S E R V I C E N O T E

8594E Spectrum Analyzer

Counter-Lock Assembly modification to improve marker count stability under certain conditions.

Figure 1. A25 Counter-Lock Assembly

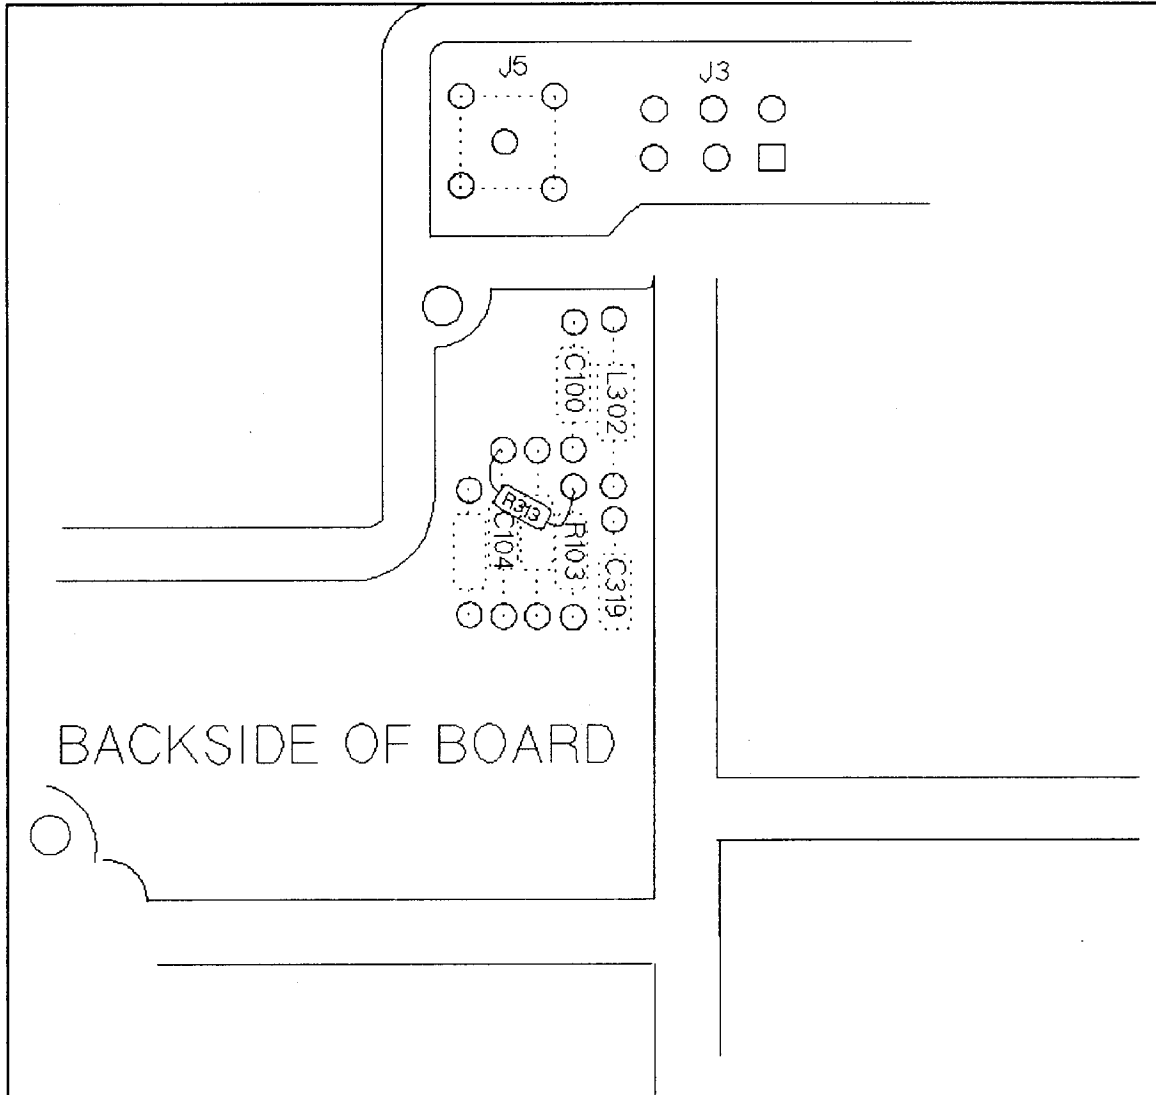
Instruments which have the A25 Counter Lock Assembly with P/N 08591-60053 or 08591-60061 may experience non-stable marker count readings. These non-stable counts are a problem while using marker count on AM modulated signals in wide Resolution BW's. When counting AM modulated signals (like the visual carrier of a TV signal) we have un-wanted modulation (15.7KHz sync rate) on the VIDEO_IF signal being combined with the COUNTER 21.4MHz input signal.

Add a high-pass filter circuit (corner freq of 1.4MHz) to the COUNT IF1(Block M) circuit which blocks the unwanted low frequency modulation signal and allows the 21.4MHz to pass through with very little loss.

1. Reference the A25 Counter-Lock Assembly Removal procedure. The procedure is located in the section of Service Guide labeled “Replacing Major Assemblies” on pages 7-41 and 7-42.
2. Remove the screw securing the two halves of the casting. Separate the casting halves and place the assembly bottom side up on the work surface.
3. Refer to Figure 1. for the location of R103 and remove R103. Install C321 in place of R103 but do not solder at this time. Install R313 as shown in Figure 1. One lead will share a hole with C321 (just installed). The other lead will share a hole with C104 as shown.
4. Apply the label (08591-60073) over the old board number.
5. Apply a label (08591-60073) onto the rear panel for future reference.
